Re: NPDES Permit No. IN0000205
ArcelorMittal Indiana Harbor, LLC – Indiana Harbor West
East Chicago, Indiana
Lake County

A response to the comments received pertaining to the draft NPDES permit is contained in the Post Public Notice Addendum. The Post Public Notice Addendum is located at the end of the Fact Sheet.

INDEX
for
ArcelorMittal Indiana Harbor West NPDES Permit IN0000205

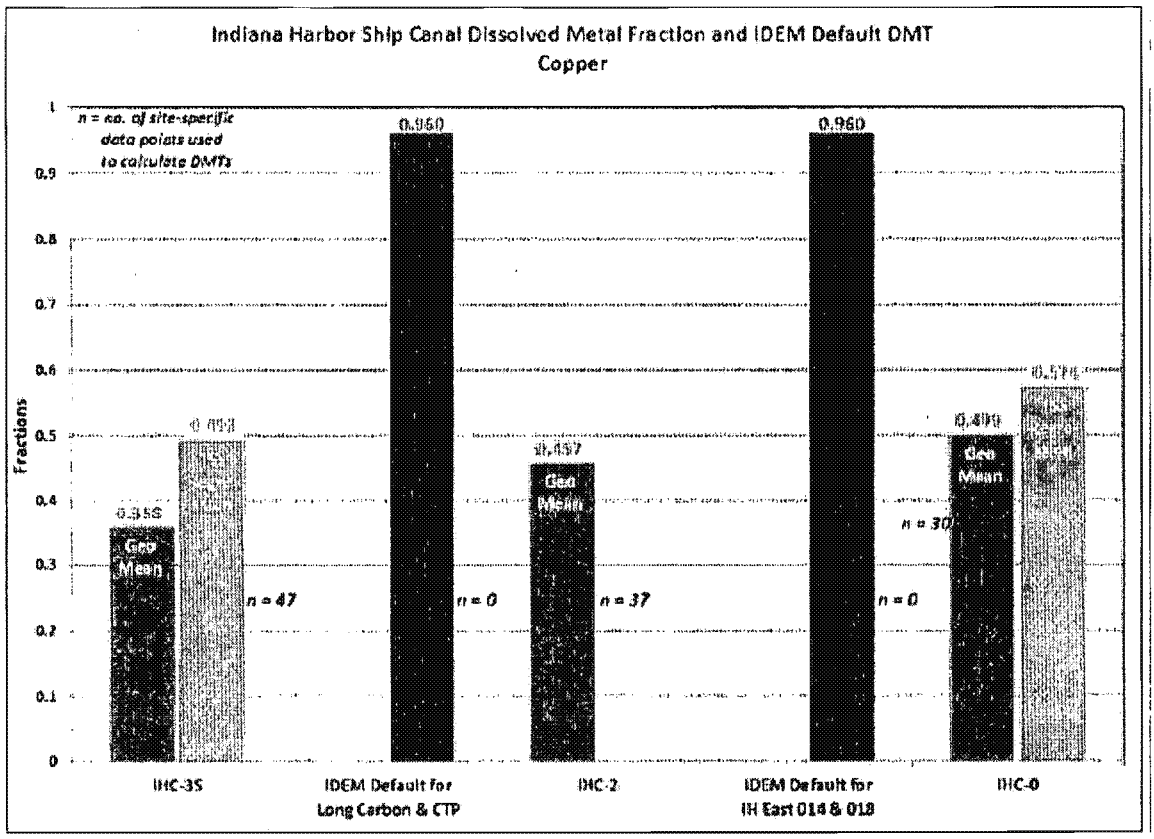
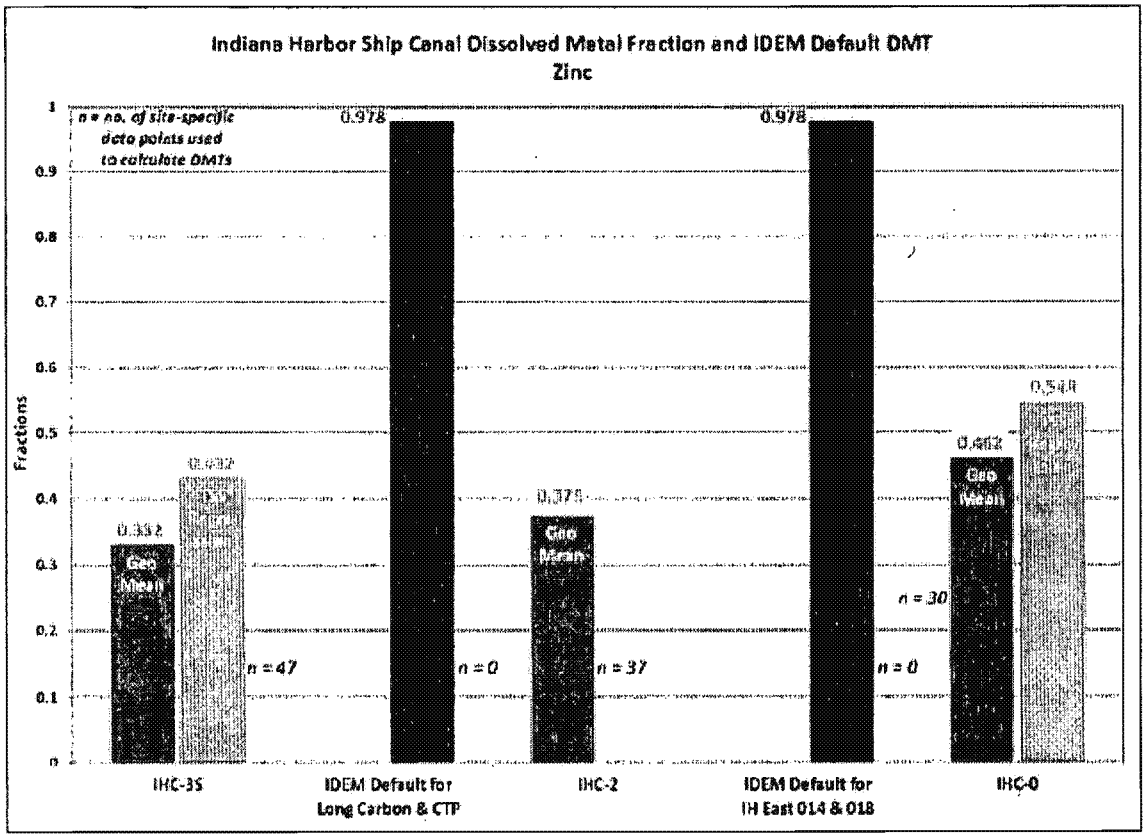
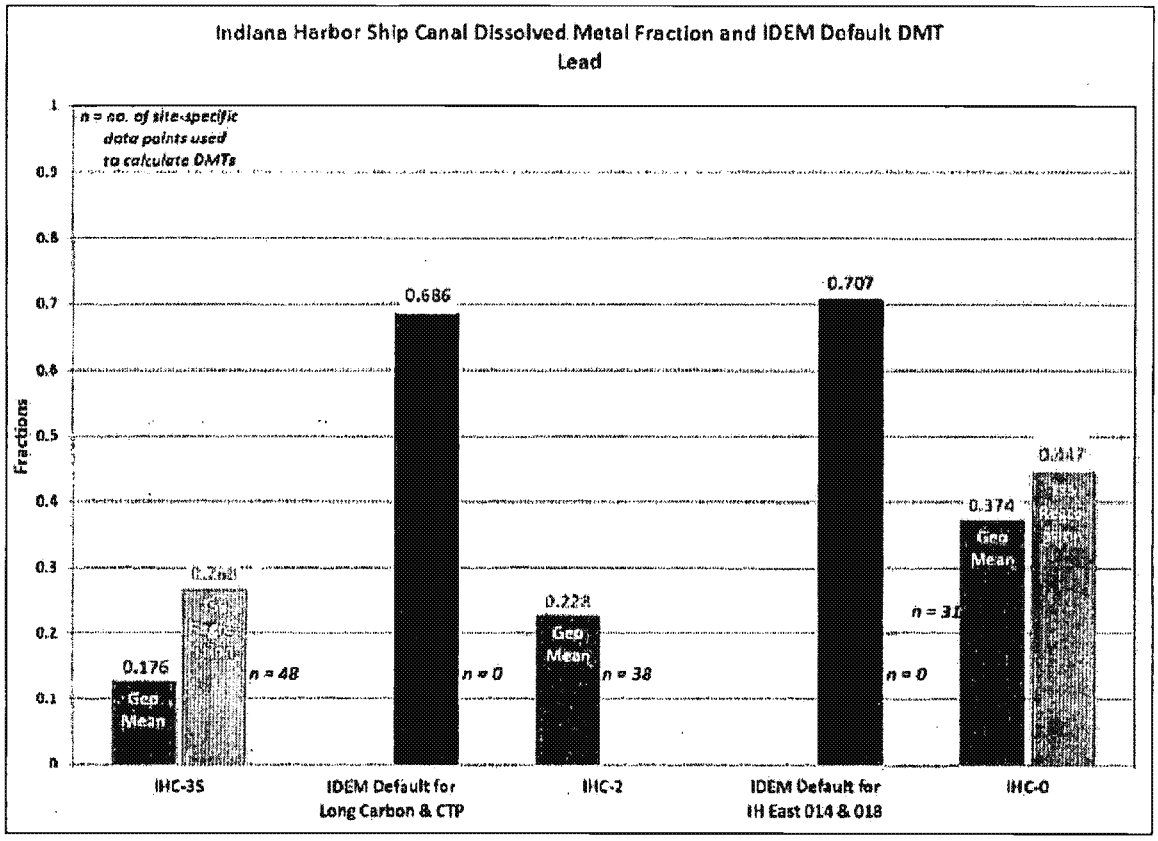
IDEM's default DMTs, which rely on no data specific to the IHSC, are clearly inaccurate for the ArcelorMittal permits and overestimate the dissolved copper, lead and zinc fractions in the IHSC by significant amounts. For example, the default translators are 2.1, 3.0 and 2.6 times greater than the calculated geometric mean of the dissolved fractions for copper, lead and zinc, respectively, at IHC-2. Even the 95th percentiles of the dissolved fractions for all metals at all locations are significantly below IDEM's default translators. As shown, the DMTs calculated at IHC-3S, IHC-2 and IHC-0 are considerably lower than IDEM's default DMTs used in the calculation of WQBELs. Graphs of the geometric mean dissolved fractions, TSS-regression developed DMTs, and IDEMs default DMTs are presented below.

Given the data presented in the table and graphs above, it is not reasonable to assume, as IDEM has done through use of the default DMTs, that the dissolved metal fraction in the water column somehow increases dramatically in between the fixed monitoring stations. ArcelorMittal's requested effluent limits, based upon site-specific DMTs derived from the IDEM fixed monitoring station data and other factors, are presented below.

ArcelorMittal Indiana Harbor West Intake No. 3 to the open waters of Lake Michigan:	~1,100 feet (~0.21 miles)
ArcelorMittal Indiana Harbor West Intake No. 2 to the open waters of Lake Michigan:	~5,300 feet (~1.0 miles)

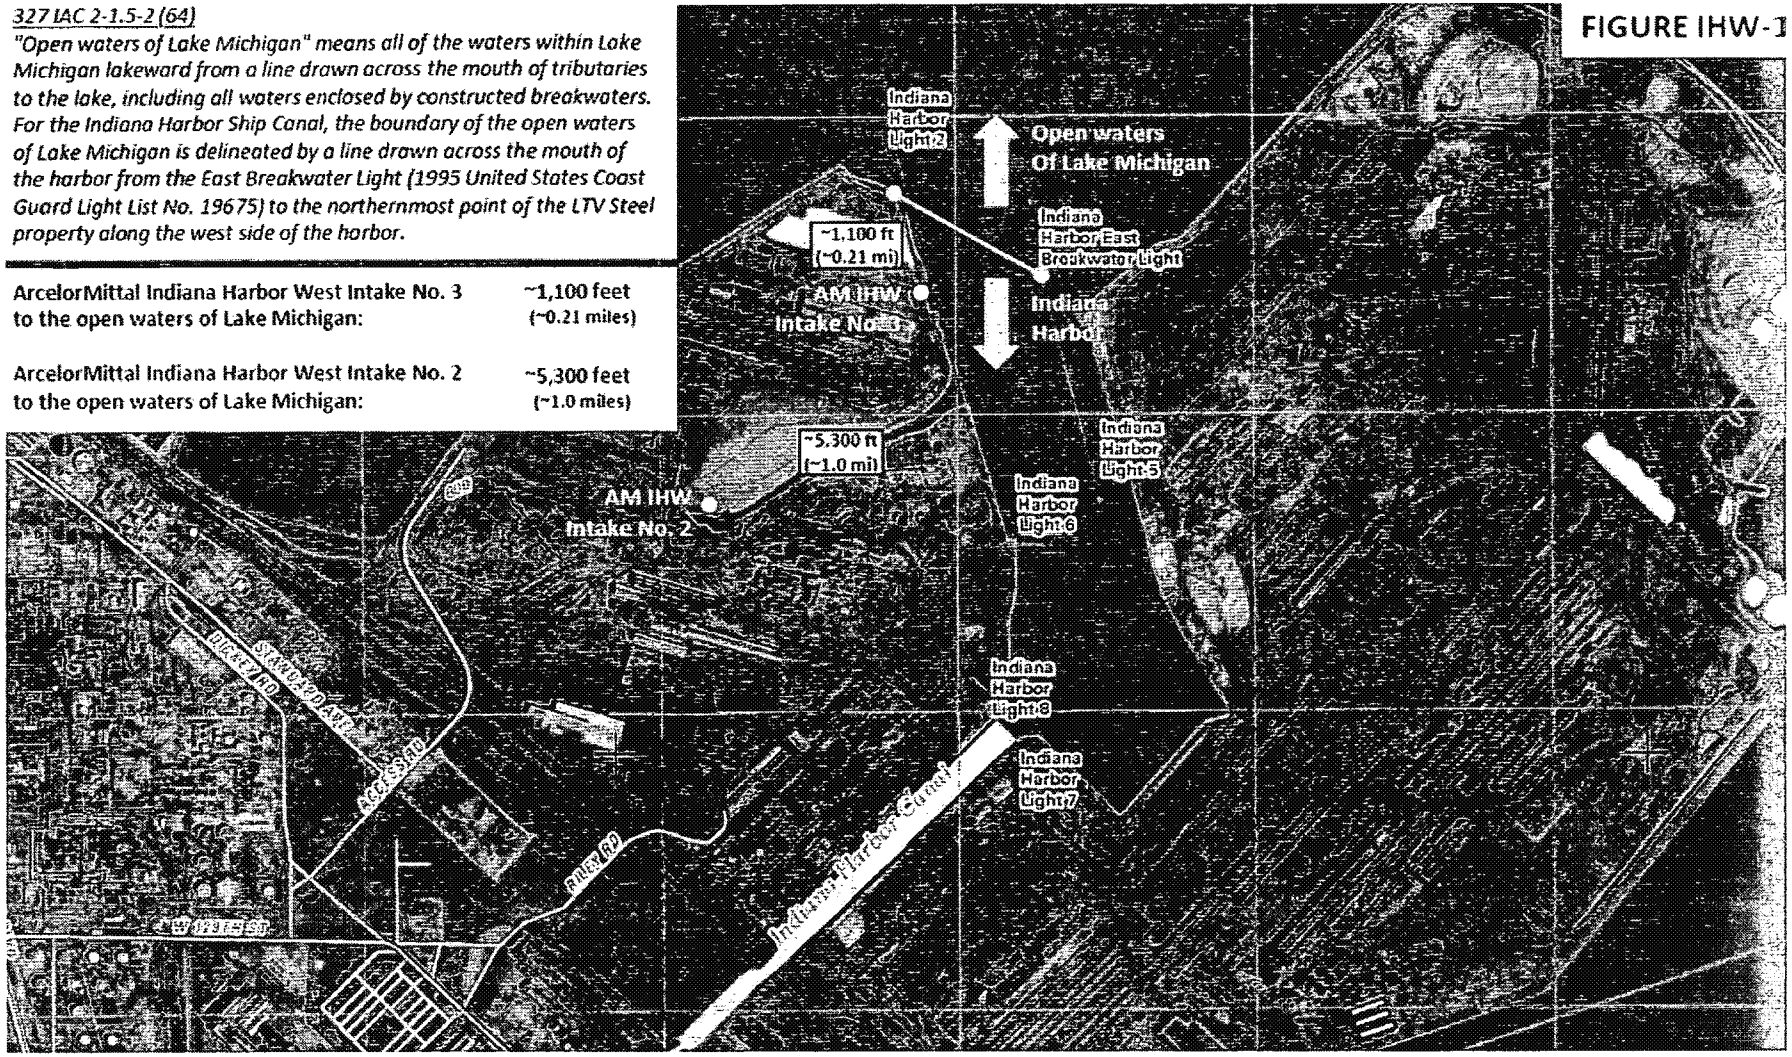
IDEM states in Attachment A of the Fact Sheet (p. 5), that Indiana Harbor West has two water intakes in Lake Michigan; and, that IDEM considers the intake channel for the Nos. 2 and 3 intakes as "open waters of Lake Michigan" (p. 12). Figure IHW-1 is an aerial photograph showing the Nos. 2 and 3 intakes, the intake channel and the northern section of the Indiana Harbor Ship canal that borders the open waters of Lake Michigan. A line depicting the boundary described in the above definition of "open waters of Lake Michigan" is shown on the aerial photograph. It is evident from a simple reading of the regulatory definition of "open waters of Lake Michigan" and review of the aerial photograph that the Indiana Harbor West intake channel and the Nos. 2 and 3 intakes are not within open waters of Lake Michigan. They are not lakeward of the line between the East Breakwater Light and the northernmost point of LTV Steel property (now ArcelorMittal Indiana Harbor LLC property). In fact, the No. 3 Intake is approximately 0.21 miles south of the northernmost point of ArcelorMittal property and the No. 2 intake is approximately 1.0 miles south and southwest of the northernmost point of ArcelorMittal property. Thus, IDEM's assertion that the intake channel for the Nos. 2 and 3 intakes are within the open waters of Lake Michigan is wrong, and any applications of Indiana water quality
